Number: 737-24-1206
Original Issue: April 03, 2014
ATA System: 2400

SUBJECT: ELECTRICAL POWER - General - E8-1 Shelf Assembly - Vinyl Marker Replacement

BOEING SERVICE BULLETIN 737-24-1206

**E8-1 ELECTRONICS SHELF
(TYPICAL)**

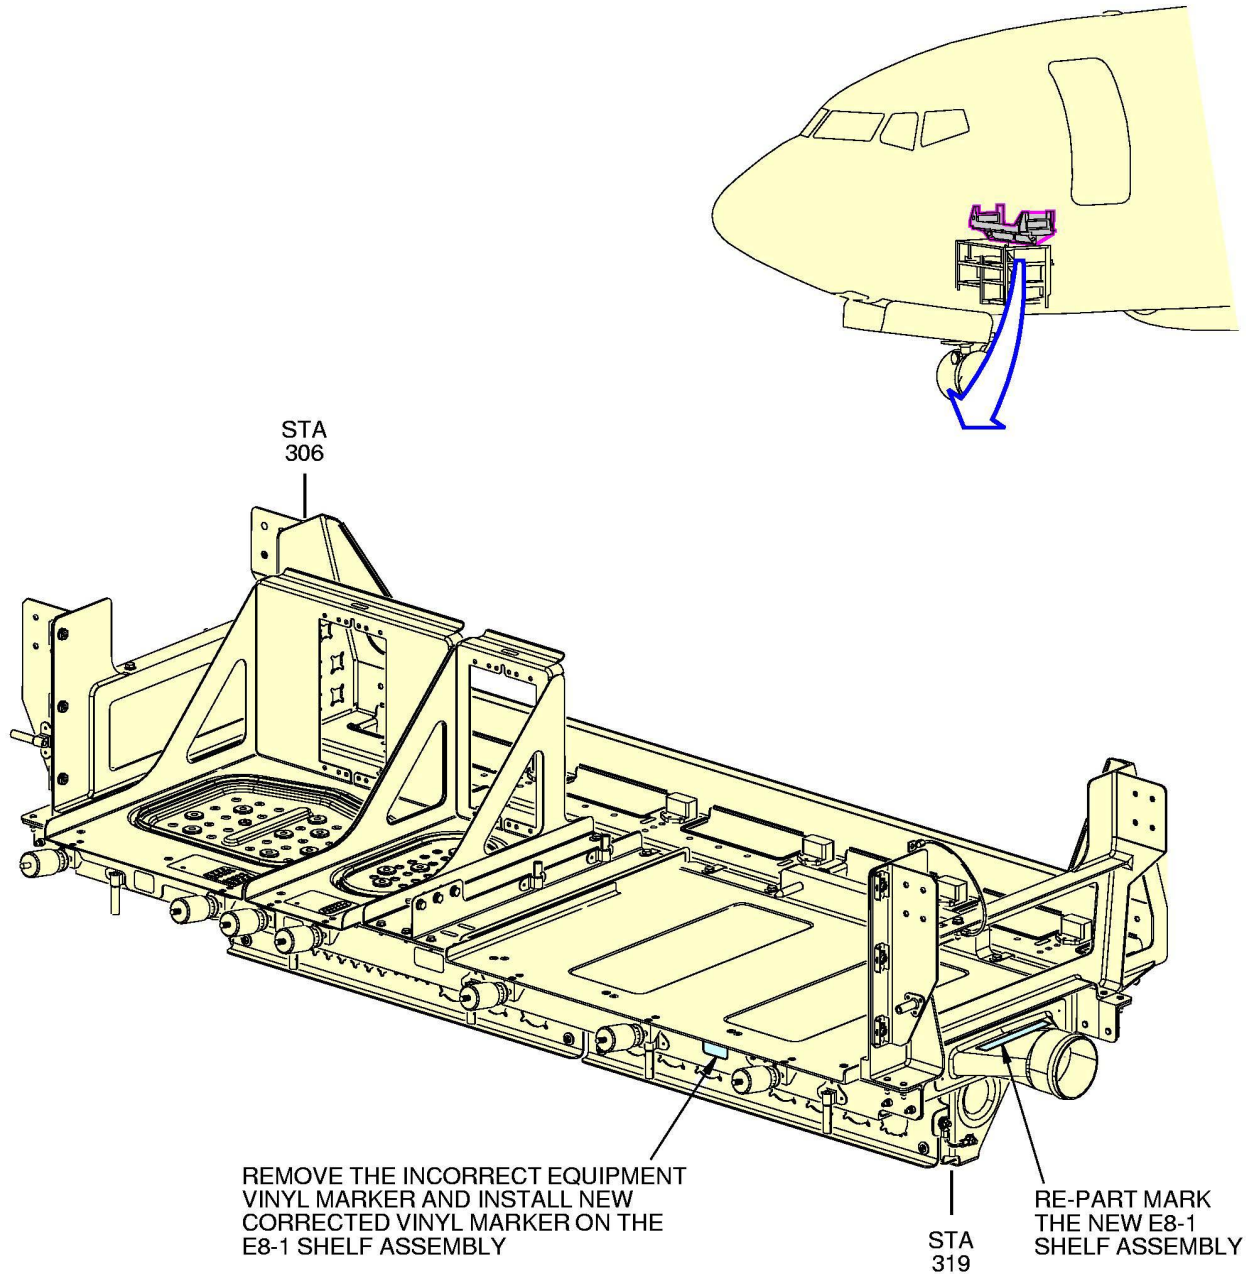
This service bulletin gives instructions to replace a vinyl marker on the E8-1 shelf assembly (located in the electrical/electronics compartment above the E1 Rack). The marker shows an incorrect electrical equipment item number and is not in accordance with airplane schematics. If the change given in this service bulletin is not done, misidentified equipment could cause potential damage to the airplane and injury to personnel.

Open access to the electrical/electronics compartment. Remove the incorrect equipment vinyl marker. Install the new corrected vinyl marker. Re-part mark the new E8-1 shelf assembly.

**FIGURE 1: REPLACEMENT OF THE E8-1 SHELF ASSEMBLY VINYL MARKER
(SHEET 1 OF 2)**

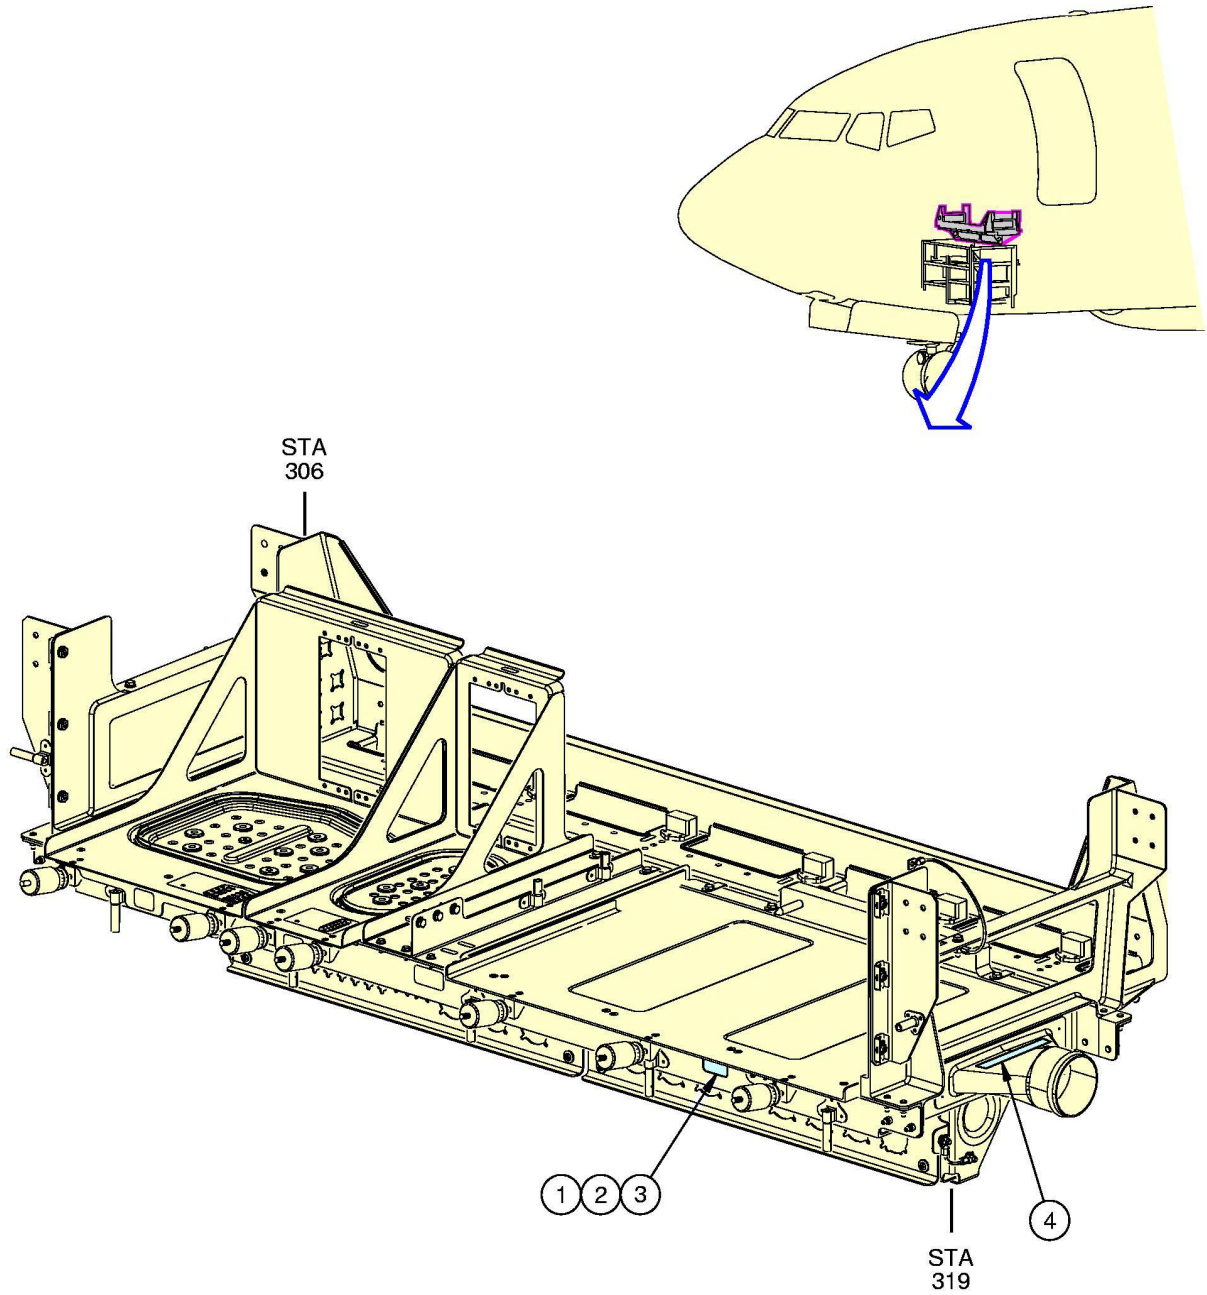
1. Open access to the electrical/electronics compartment. Refer to 737-600/700/800/900 AMM 06-41-00 as an accepted procedure.
2. Change the E8-1 shelf assembly vinyl marker in accordance with FIGURE 1.
3. Close access to the electrical/electronics compartment. Refer to 737-600/700/800/900 AMM 06-41-00 as an accepted procedure.
4. Put the airplane back to a serviceable condition.

Step	Task	Name	Identification	Qty	More Data
1	Remove	MARKER	BAC27DEX7203	1	Refer to SOPM 20-50-05 as an accepted procedure.
2	Clean	SURFACES	ISOPROPYL ALCOHOL, TT-I-735, OR EQUIVALENT	4 Oz	Refer to SOPM 20-30-03 as an accepted procedure.
3	Install (New)	MARKER	284A6002-12	1	In location of existing marker, as shown. Refer to SOPM 20-50-05 as an accepted procedure.
4	Identify	SHELF SUBASSY - E8-1, E/E EQUIPMENT	284A1781-77 (FOR EXISTING 284A1781-67)	1	With new dash number. Refer to SOPM 20-50-10 as an accepted procedure.
